**ZONING AMENDMENT,
PLANNED UNIT DEVELOPMENT &
SUBDIVISION STAFF REPORT**

Date: July 19, 2007

Franklin Primary Health Center, Inc.

Franklin Primary Health Center Subdivision, Unit Two

SITE PLAN

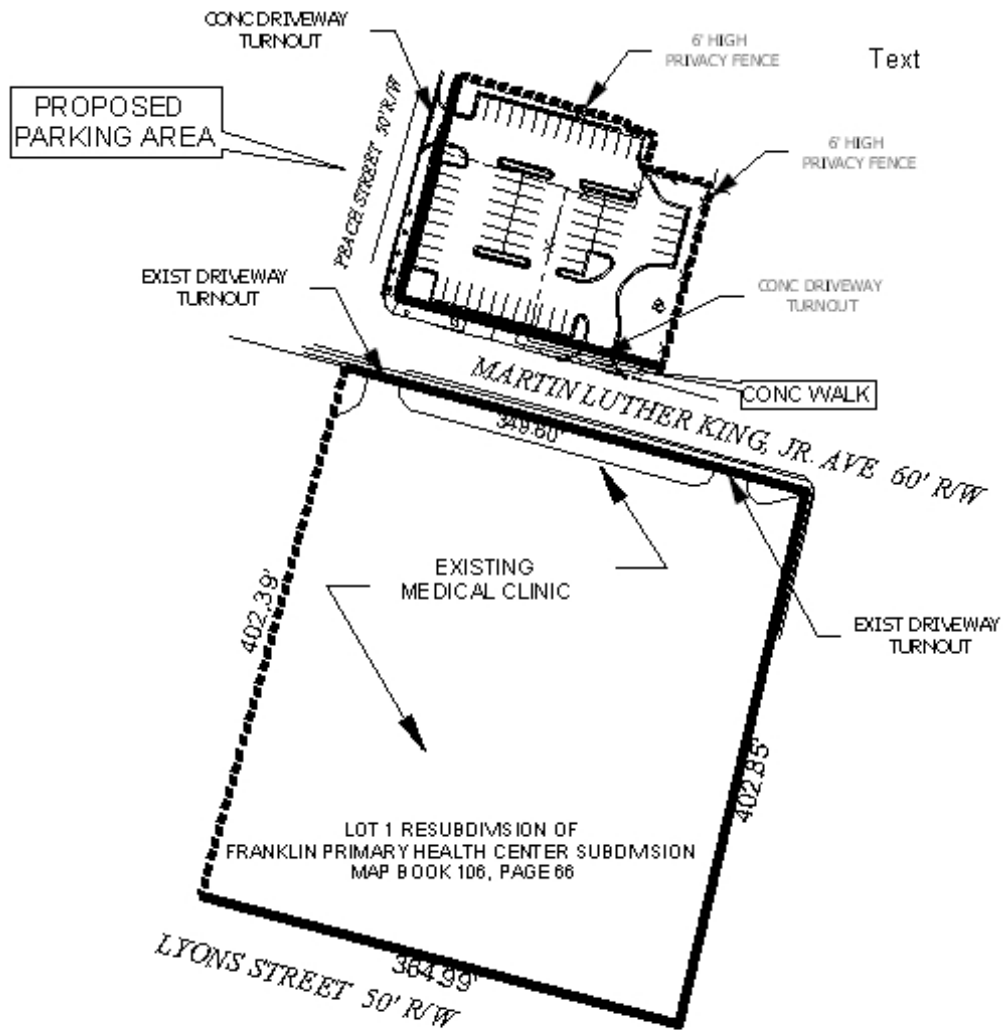
The parking lot, as proposed, will contain 66 parking spaces, and will have one curb-cut onto Dr. Martin Luther King, Jr. Avenue and one curb-cut onto Peach Street. A six-foot high privacy fence is proposed along the Northern and Eastern boundaries of the parking lot site where it abuts R-1 zoned properties, in compliance with Section 64-4.D.1. of the Zoning Ordinance.

Section 64-4.A.3.i. of the Zoning Ordinance requires that parking areas separated from an R-1 area (across Peach Street) shall have a brick wall or evergreen hedge of a minimum height of five and one half feet and a maximum of eight feet, placed five feet inside the street property line. The PUD and Zoning site plan should be revised to reflect this requirement.

As a commercial parking lot, full compliance with the tree and landscaping requirements of the Zoning Ordinance will be necessary. Existing trees on the site may reduce the number of new trees required, however, no calculations regarding required trees and tree credits have been provided. Detailed landscaping information will be required prior to the issuance of permits for construction.

The site is currently unpaved and undeveloped. New construction may require compliance with the Engineering Department's storm water and flood control regulations. If a storm water detention facility is required, the site plan should be revised to depict the facility.

Any existing curb-cuts that will not be used for the parking lot should be removed and the right-of-way area restored to grass or other acceptable ground cover.

Finally, it would be beneficial if the site plan directed pedestrians to the Peach Street / Dr. Martin Luther King, Jr. Avenue intersection to cross the street to the health center.

- 2) revision of the site plan for the proposed parking lot to depict one curb-cut onto Dr. Martin Luther King, Jr. Avenue, and no curb-cut onto Peach Street;

- 3) revision of the site plan to depict parking area buffering in compliance with Section 64-4.A.3.i. of the Zoning Ordinance, where the proposed parking lot abuts or is across the street from residential zoning districts;

- 4) revision of the site plan to place the requirements of Section 64-6.A.3.c., *Lighting*, as a note on the site plan: *"If parking areas contain ten (10) or more cars, lighting shall be provided and maintained during their operation, and shall be so arranged that the source of light does not shine directly into adjacent residential properties or into traffic."*

- 5) revision of the site plan to depict compliance with the tree and landscaping requirements of the Zoning Ordinance for the proposed parking area;
- 6) revision of the site plan to depict a storm water detention area for the proposed parking area, if required;

- 7) revision of the site plan for the proposed parking area to depict complete removal of any existing, unused curb-cuts, and provision of appropriate landscaping for those areas;

- 8) revision of the site plan to direct pedestrian traffic from the proposed parking area to the intersection of Peach Street and Dr. Martin Luther King, Jr. Avenue for street crossing to the health center;
- 9) provision of a revised PUD site plan (and parking area specific site plan) to the Planning Section of Urban Development prior to the signing of the final subdivision plat; and
- 10) full compliance with all other municipal codes and ordinances.
